**From:** Wickham, Jerry, Env. Health  
**Sent:** Wednesday, November 12, 2014 8:16 AM  
**To:** 'Peter Sims'  
**Subject:** RE: Ashland Housing Project  
**Attachments:** RO3122\_Building A Excavation Sampling Locations rev2.pdf

**Subject:** Ashland Housing Project

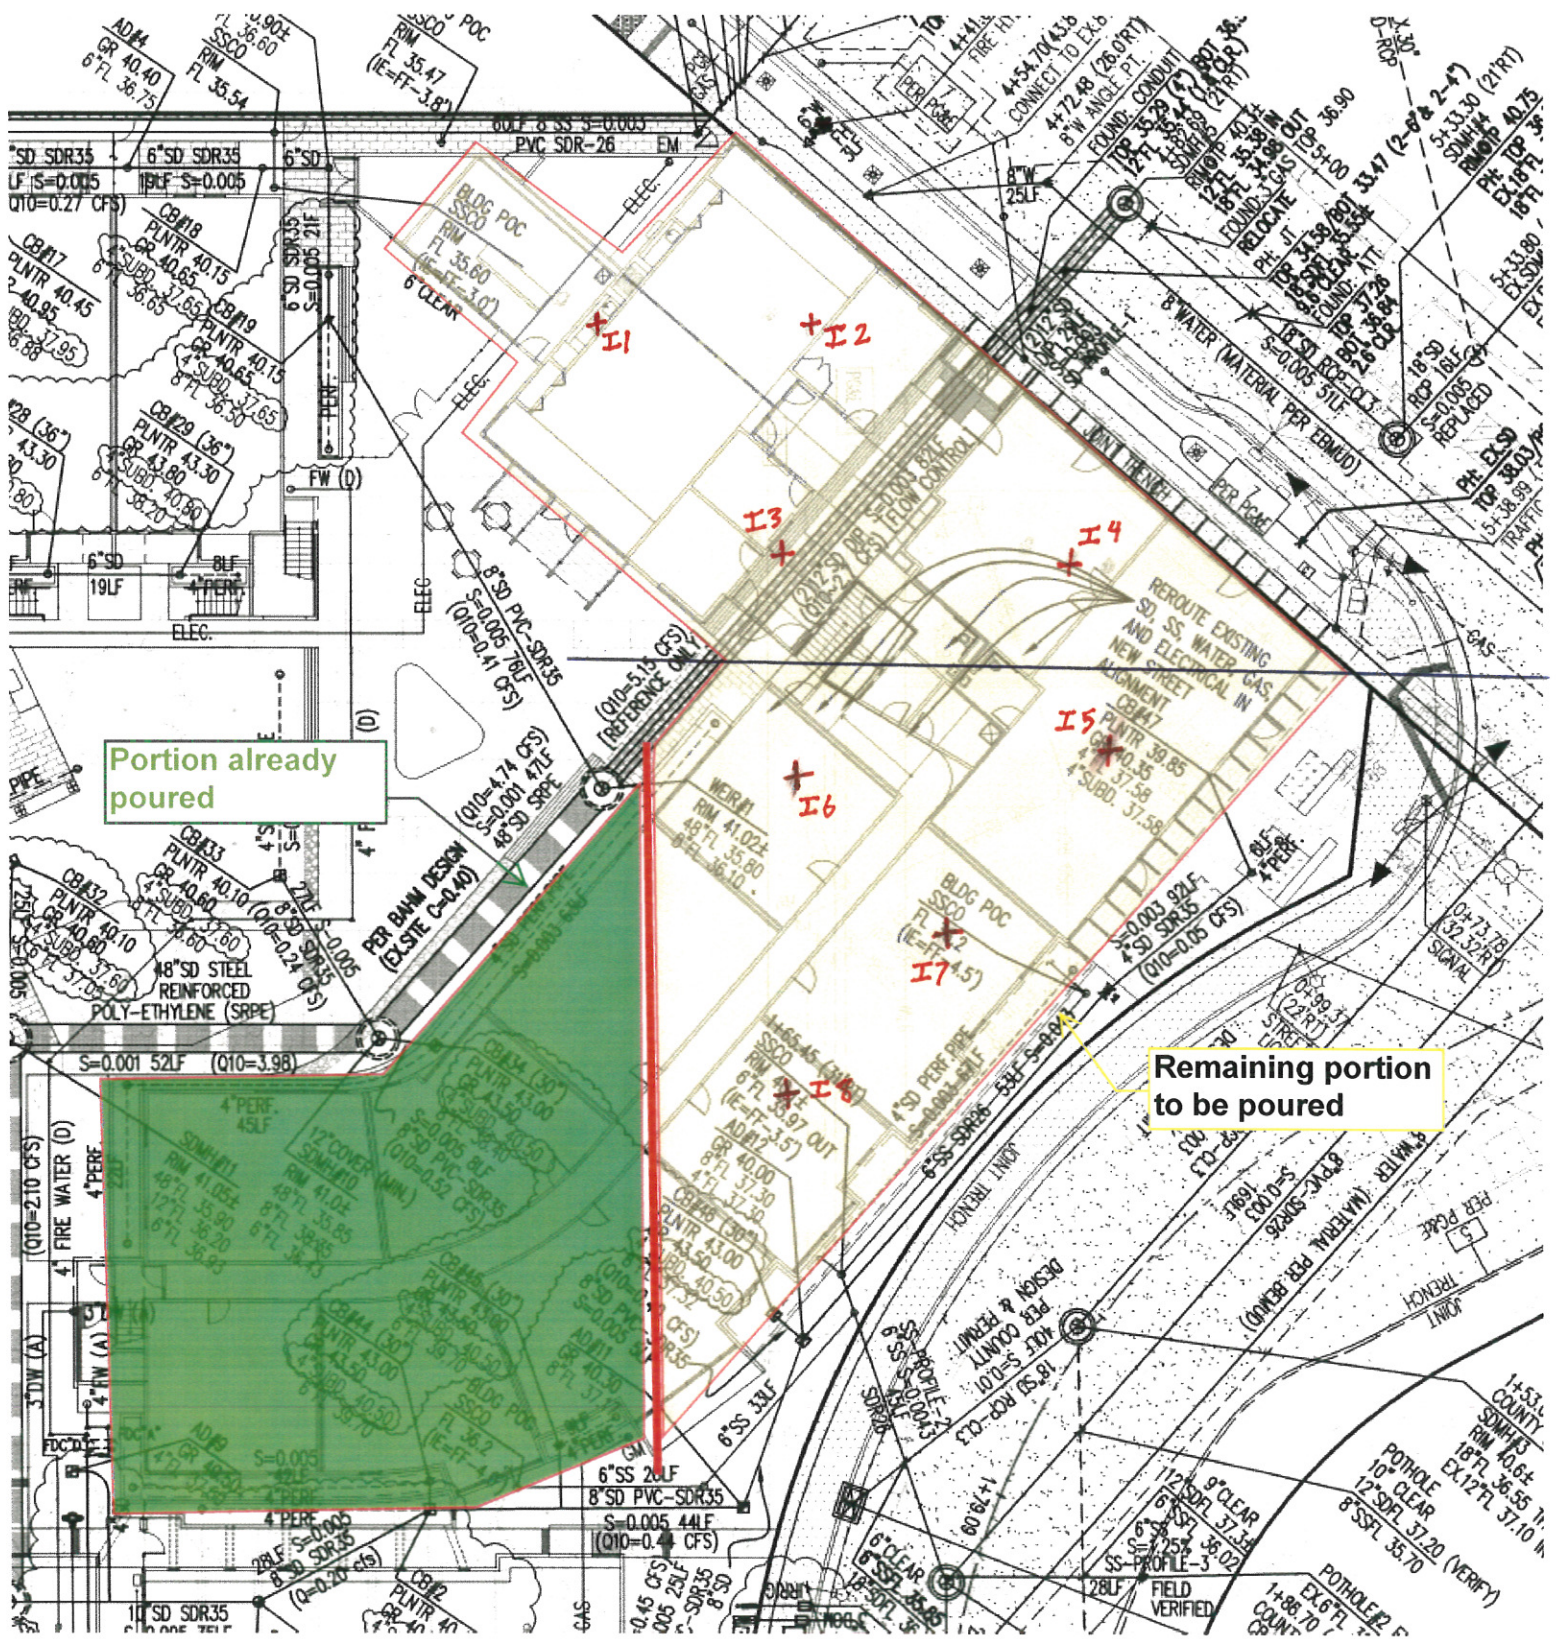
The contractor has notified me that a portion of the concrete at Building A has already been poured and will not be excavated. The attached figure shows revised sampling locations.

Portion already poured

Remaining portion to be poured

The revised sampling locations consisting of eight borings shown on the attached figure are acceptable as proposed.
